# ***Rouse Hill Anglican College Redevelopment***

State Significant  
Development  
Modification Assessment  
(SSD 8006 MOD 2)

February 2020

**Figure 5 |** Approved western elevation (Source: Applicant's Modification Application 2020)

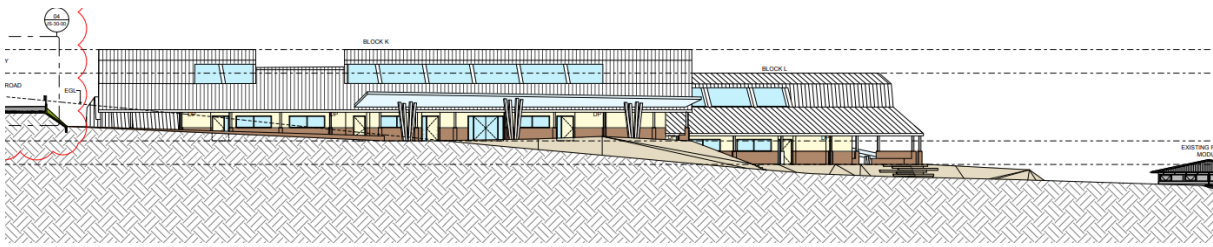
- External/Landscaping Works
  - Lift relocated to fully external lift at client request with upper level linking bridge in lieu of lower level access tunnel. Minor adjustment to stair alignment adjacent to coordinate with new lift position. Associated small adjustments to the extent/shape of proposed canopies.

- Reduced extent of concrete ramping to south of Block L & M to increase areas available as sloped play space.
  - Relocation of canteen adjacent to stair linking existing lower level and new upper level classroom modules to more directly face onto main pedestrian access with additional soft landscaping in former canteen zone.

- Additional tree planting adjacent to ramping south of Block L.
  - New secured access gate/entry to northern road for improved fire brigade servicing of Block L with associated refinement of adjacent terracing/amphitheatre zone.

- Refinement of ramping/terracing/stairs between Block K and Block L and associated covering canopies to increase area of level play space which incorporates additional soft landscaping surfaces to assist in reducing radiant heat in this zone.
